8 VALVE AW 1939
RADIO (1936) LTD AUCK.

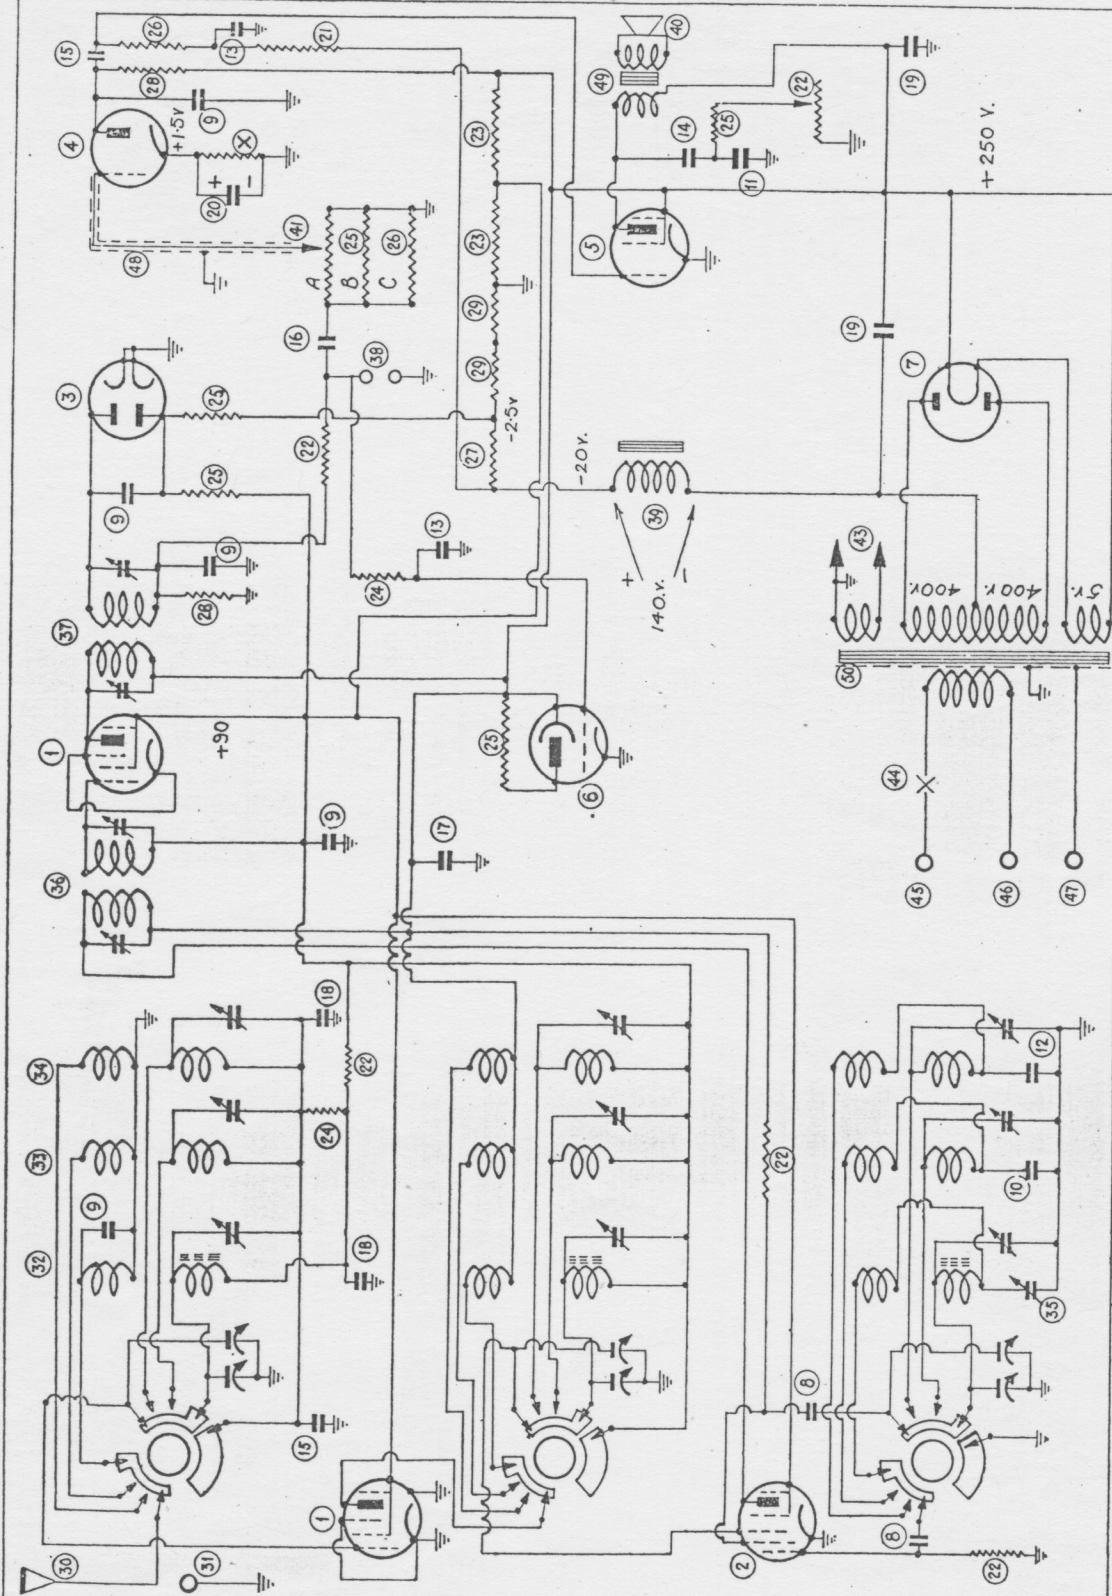
AMENDMENTS
6J7 Replaced by 6F5 from 18-439
6J7 Screen was fed thru 500 000
from other RF screens by posses
with .25 u/d - A.B.C now a single 4u
